1st Review
Aurora Water
Jennifer Wynn
jwynn@auroragov.org

Highline Village 4
Apartments

HIGHLINE VILLAGE 4 APARTMENTS
SITE PLAN AND PRELIMINARY PLAT
LOT 2, BLOCK 1 HIGHLINE VILLAGE,
CITY OF AURORA, COUNTY OF ADAMS, STATE OF COLORADO
3.741 ACRES

WEST ELEVATION - VIEW 4

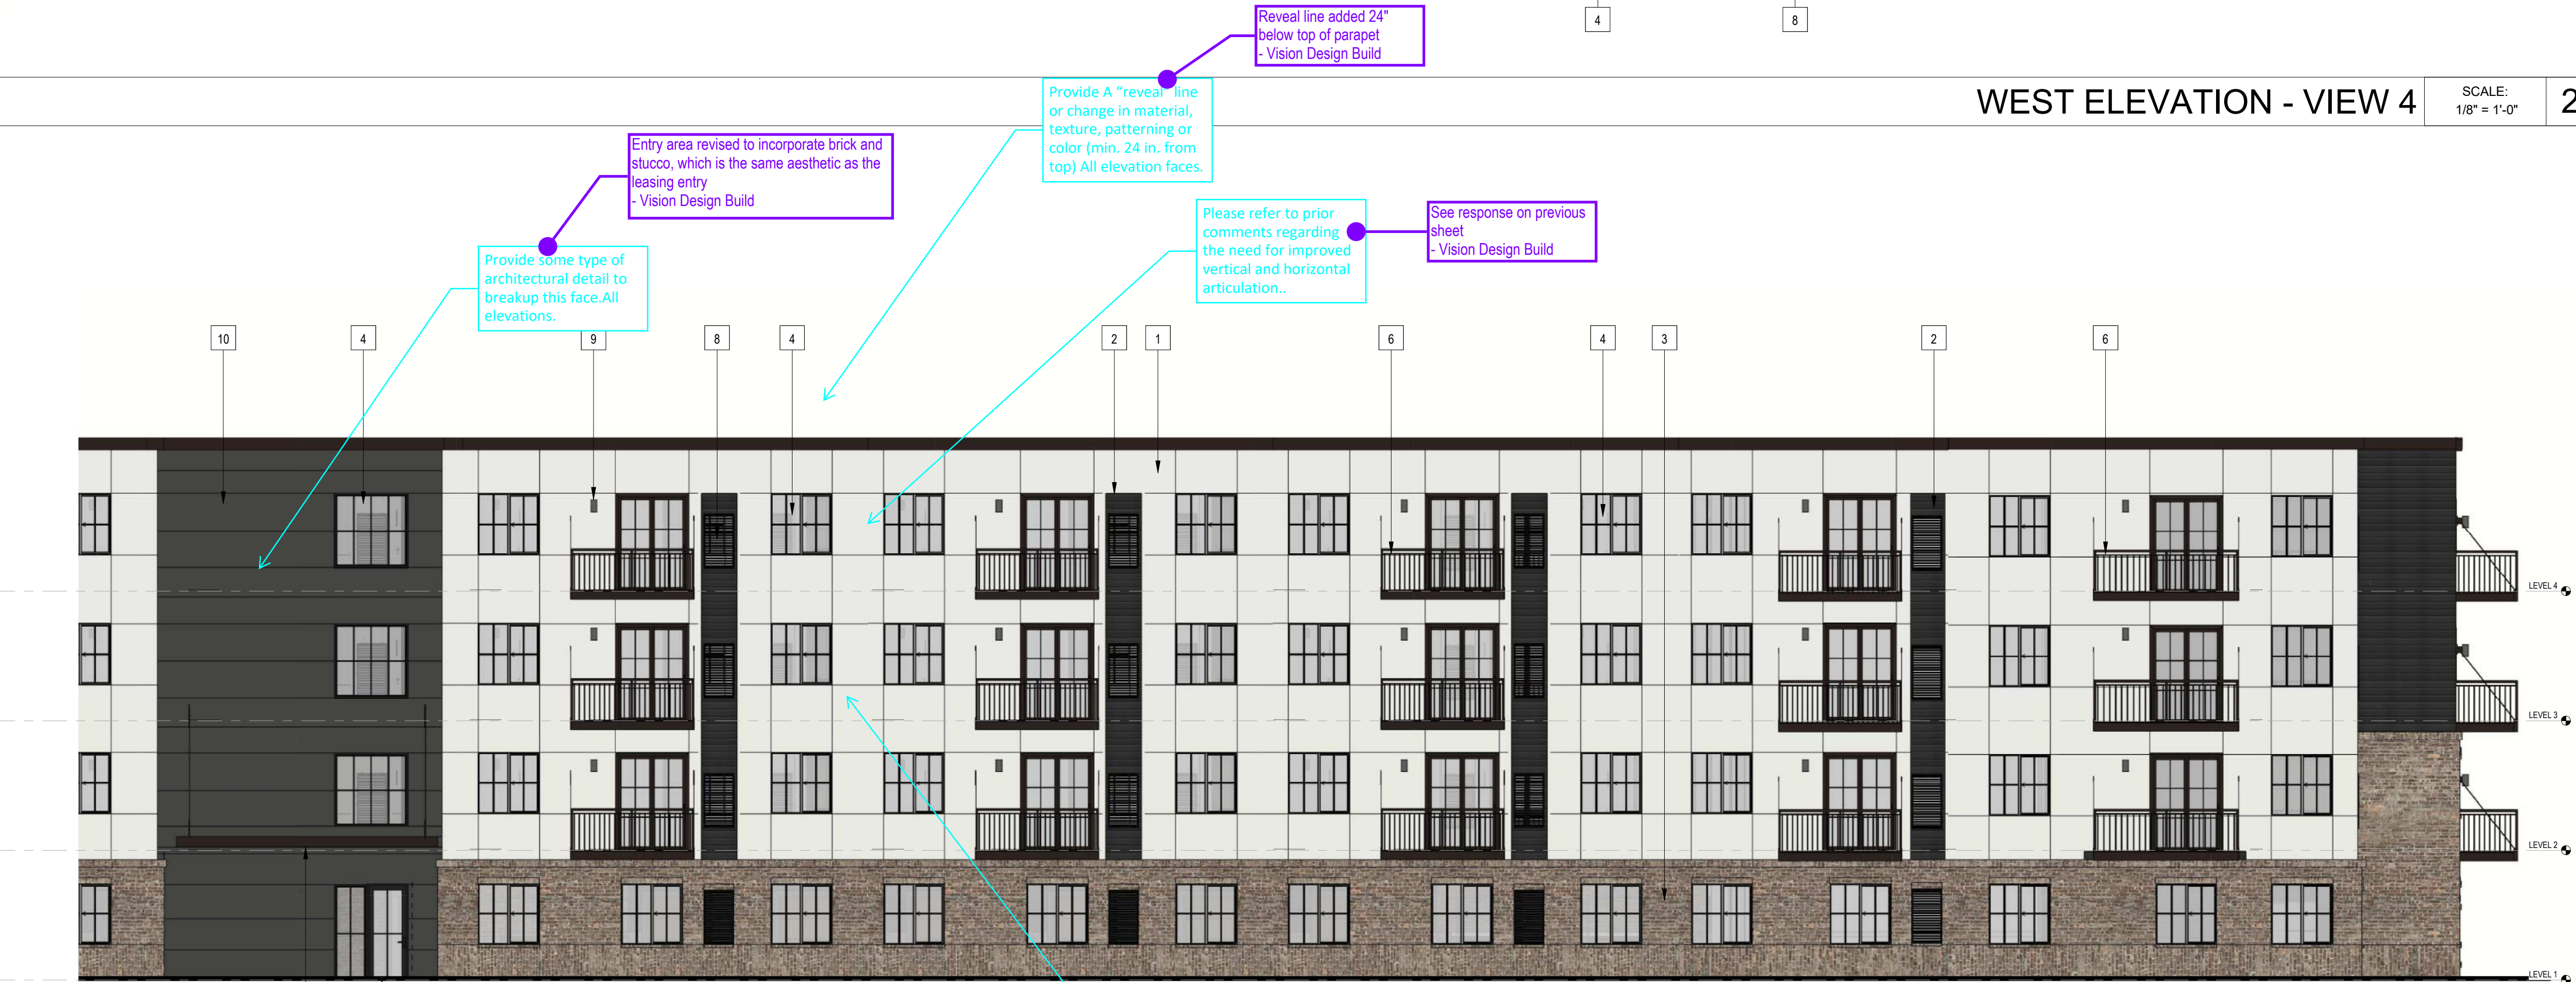
Provide building lengths and height with next submittal-all elevation sheets.

Per code section 146-4.8.5.c: Each primary structure or portion of primary structure with a height of 30 feet or more and more than two stories shall use vertical articulation to present a clear base, middle and cap to the building on each façade facing a street or a Residential zone district. Please provide a more pronounced base, middle and cap with the next submittal.

Elevation sheets must show and label the locations of Fire Department Connection (FDC), Fire Riser Room Door and Knox Box locations.

Provide material coverage for each elevation.

Building lengths and height have been added to each elevation
- Vision Design Build

Fire Sprinkler Room, and FDC location shown on East Elevation, View 6 on sheet 15
- Vision Design Build

1 PROPOSED PHOTOMETRIC PLAN
SCALE: 1"= 30'-0"

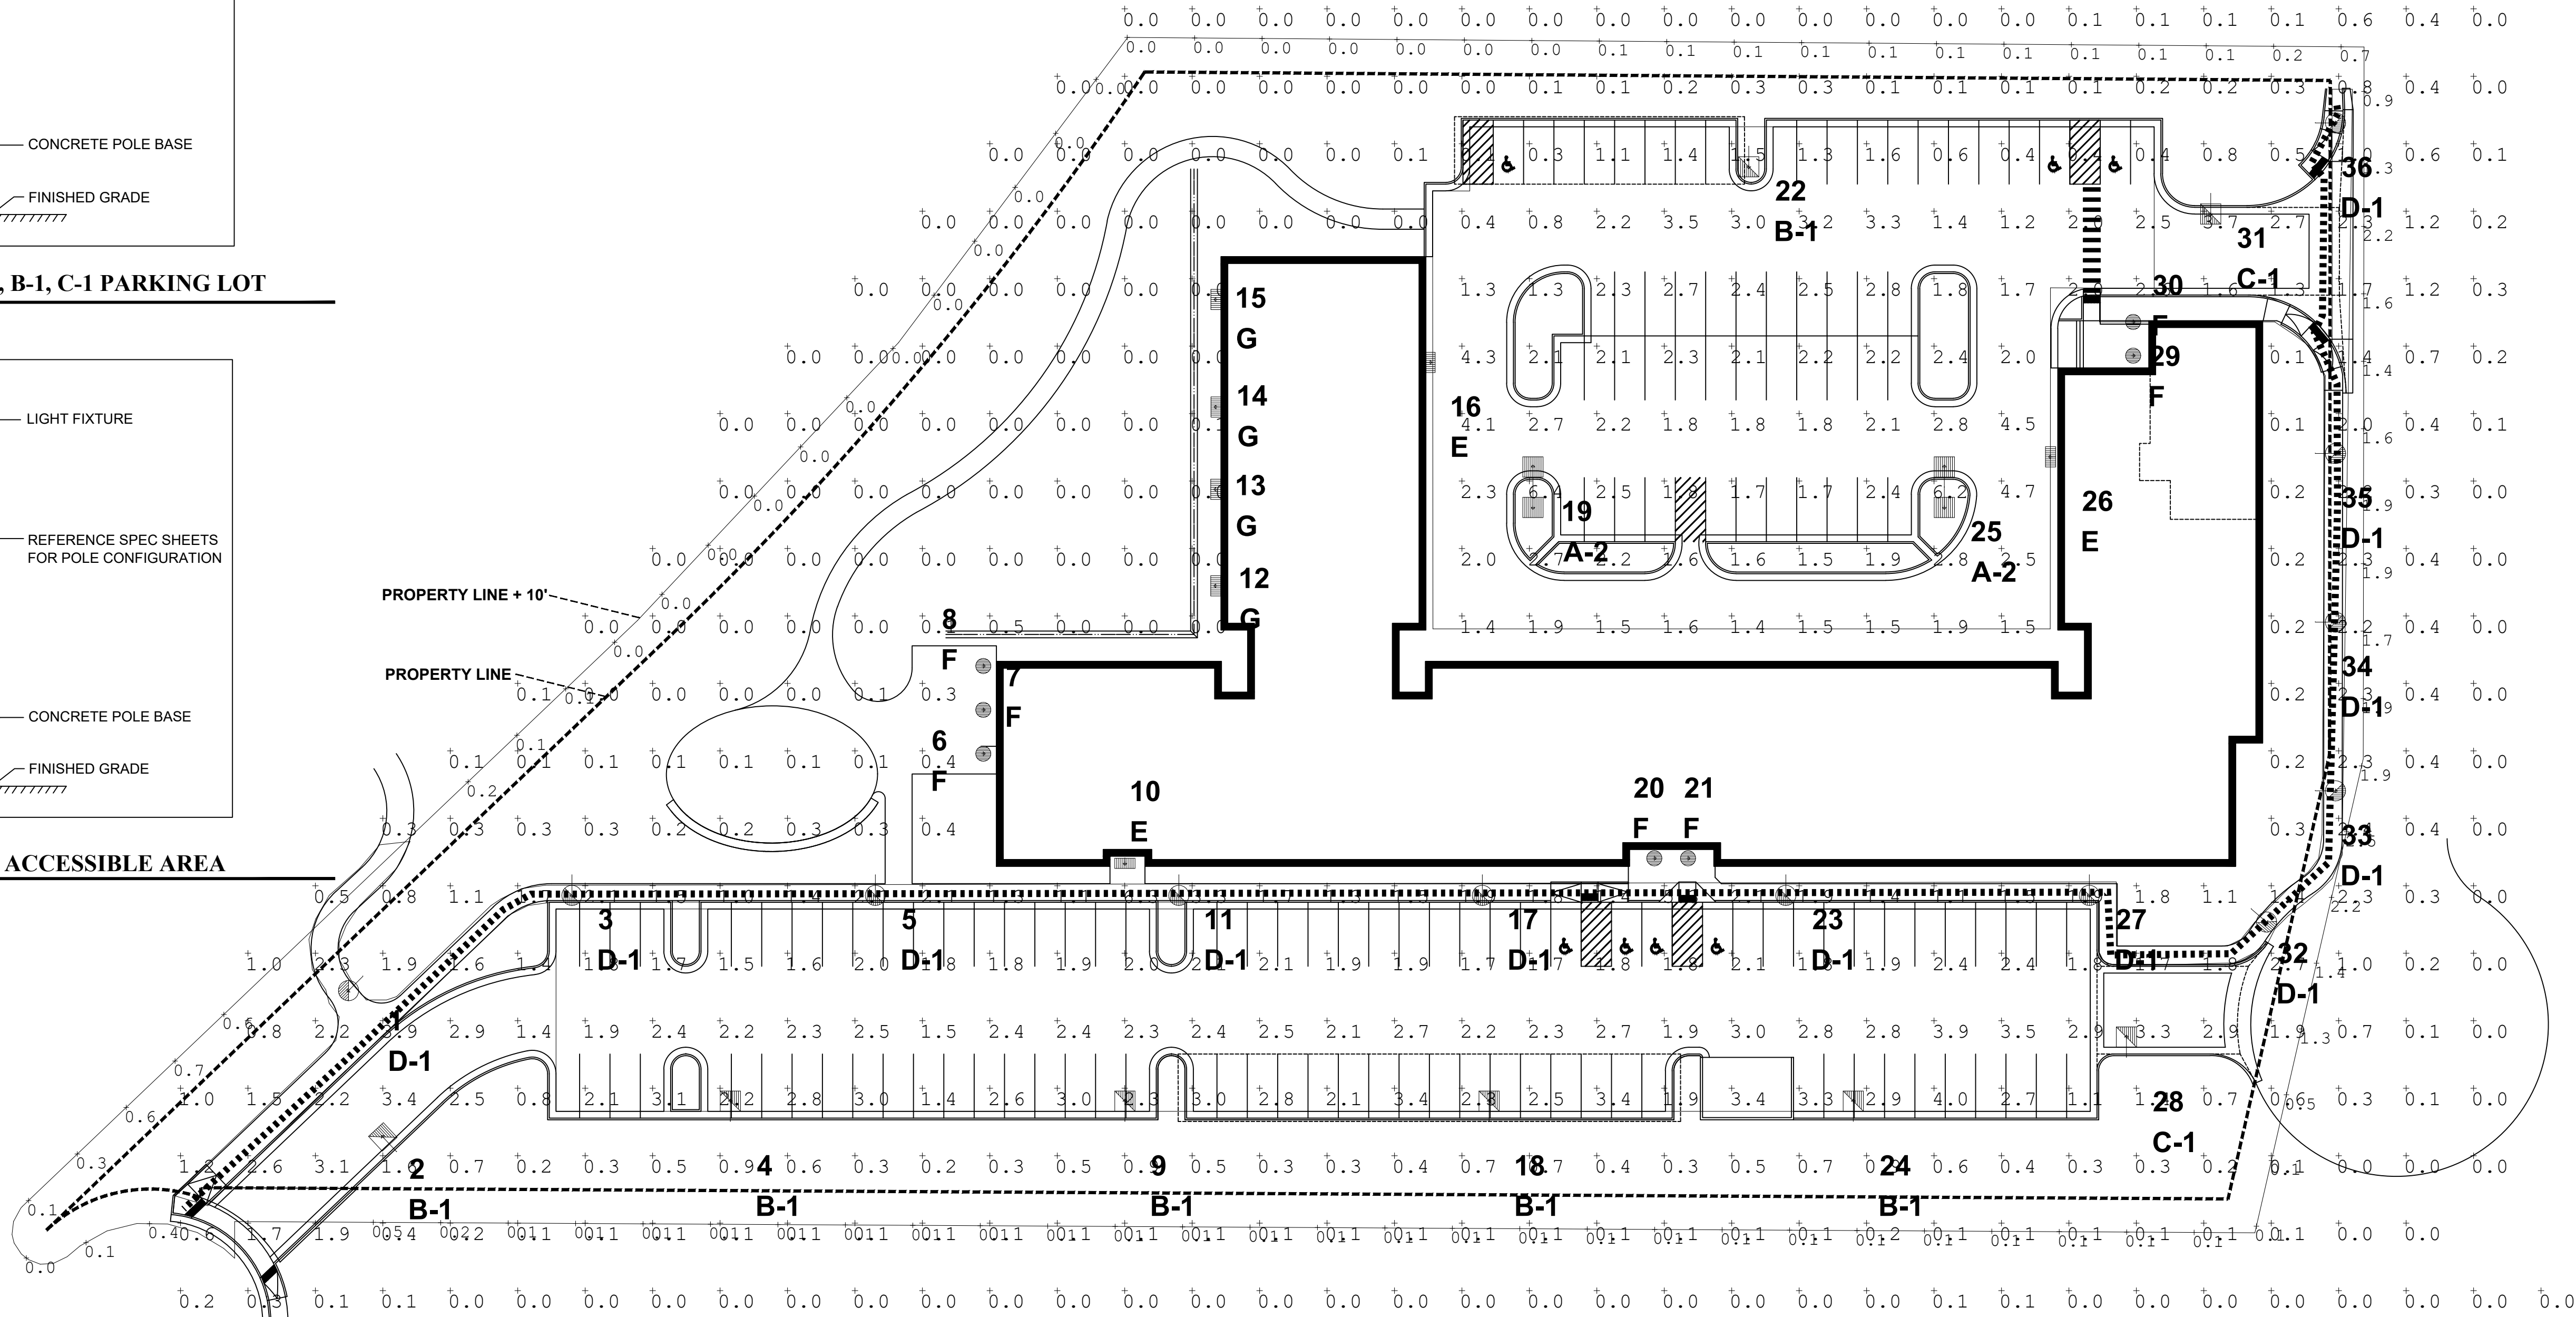
Please add the following note:
"Proposed street light locations (on ROW) are conceptual. Final locations will be determined with photometric analysis submitted with the street lighting plans in the civil plan submittal."

Show and label fire lane easements and accessible routes on photometric sheet.

Note added.
